NEWMAR CORPORATION WARRANTY DEPARTMENT

TECHNICAL SERVICE BULLETIN							
DATE ISSUED	MODEL YEAR(S) AFFECTED		MODEL(S) AFFECTED			TSB #	
10/2/2007	2007 - 2008		VTDP / ATME			324	
BRAND						TYPE	
All	<input type="checkbox"/>	American Star	<input type="checkbox"/>	Mountain Aire	<input type="checkbox"/>	All	<input type="checkbox"/> TT <input type="checkbox"/>
Ventana	<input checked="" type="checkbox"/>	Dutch Star	<input type="checkbox"/>	Kountry Aire	<input type="checkbox"/>	FW	<input type="checkbox"/> CA <input type="checkbox"/>
All Star	<input checked="" type="checkbox"/>	Kountry Star	<input type="checkbox"/>	Essex	<input type="checkbox"/>	DP	<input checked="" type="checkbox"/> DB <input type="checkbox"/>
Scottsdale	<input type="checkbox"/>	Northern Star	<input type="checkbox"/>	London Aire	<input type="checkbox"/>		
<input type="checkbox"/> Air Conditioning & Heating <input type="checkbox"/> Appliances & Accessories <input type="checkbox"/> Cabinets & Furniture <input checked="" type="checkbox"/> Chassis Components <input type="checkbox"/> Construction Components				<input type="checkbox"/> Electrical Components <input type="checkbox"/> Exterior Components <input type="checkbox"/>

FIG. 2-1

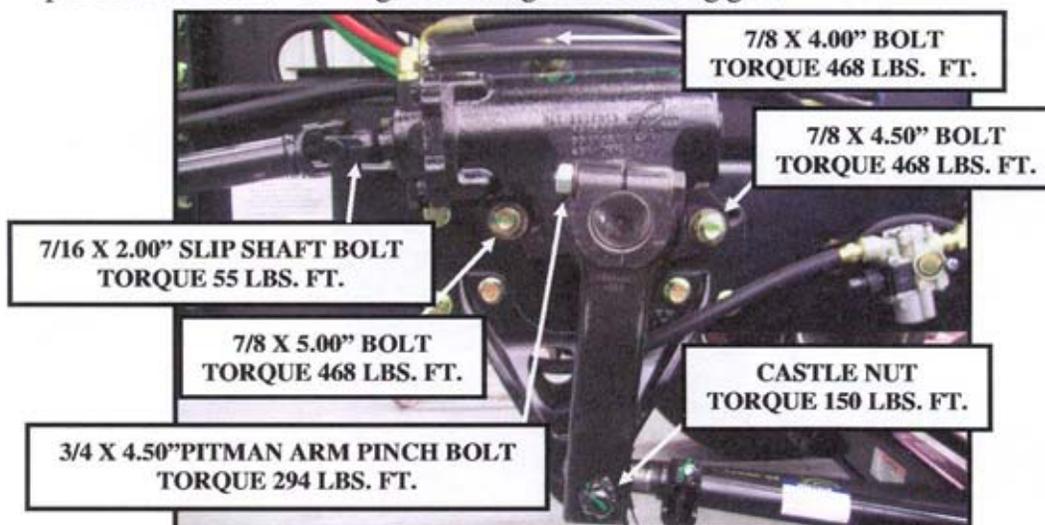
CONDITION: Steering gear seals leak

10. Refer to FIG. 2-1. Install new steering gear and steering gear support onto frame rail using new 7/8" X 4.00", 7/8" X 4.50 and 7/8" X 5.00" bolts, washers and nuts supplied in the kit.

- A. 4.00" bolt to the top mounting hole. Torque to 468 lbs. ft.
 - B. 4.50" bolt to the rear mounting hole. Torque to 468 lbs. ft.
 - C. 5.00" bolt to the front mounting hole. Torque to 468 lbs. ft.

11. Refer to FIG. 2-1. Torque pitman arm pinch bolt to 294 lbs. ft.
12. Refer to FIG. 2-1. Reconnect drag link to pitman arm using original castle nut retained from previous steps. Torque castle nut to 150 lbs. ft. Install and bend new cotter pin.

NOTE: Refer to previous note to ensure the proper indexing of steering wheel.
13. Refer to FIG. 2-1. Reconnect steering slip shaft to steering gear input shaft. Use new 7/16" X 2.00" bolt and nut supplied in kit. Torque to 55 lbs. ft.
14. Reconnect hoses to the steering gear using a new clamp on the return hose supplied in kit. Secure both hoses as needed.
15. Reconnect any power source that was disconnected in step # 1.

FIG. 3-1

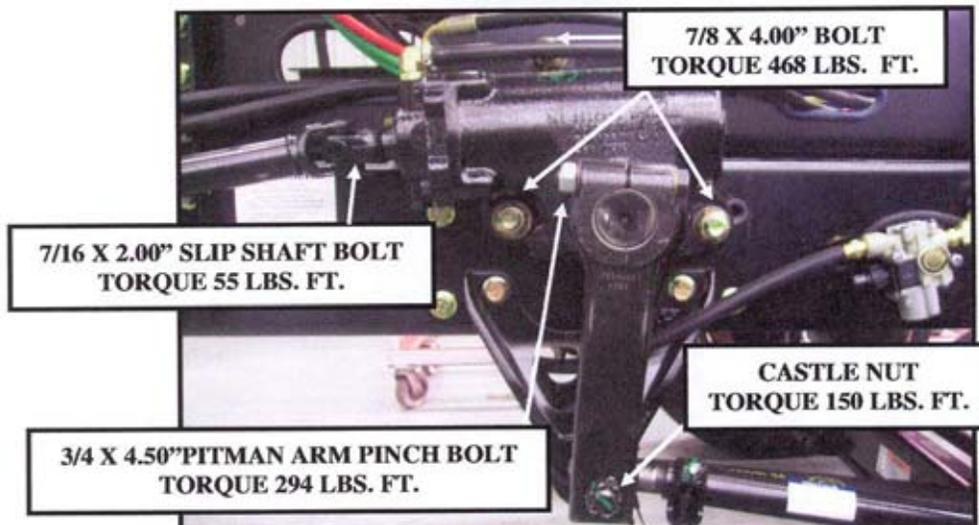
CONDITION: Steering gear seals leak.

10. Refer to FIG. 3-1. Install new steering gear and steering gear support onto frame rail using three new 7/8" X 4.00" bolts, washers and nuts supplied in the kit. Torque to 468 lbs. ft.

11. Refer to FIG. 3-1. Torque pitman arm pinch bolt to 294 lbs. ft.
12. Refer to FIG. 3-1. Reconnect drag link to pitman arm using original castle nut retained from previous steps. Torque castle nut to 150 lbs. ft. Install and bend new cotter pin.

13. Refer to FIG. 3-1. Reconnect steering slip shaft to steering gear input shaft. Use new 7/16" X 2.00" bolt and nut supplied in kit. Torque to 55 lbs. ft.
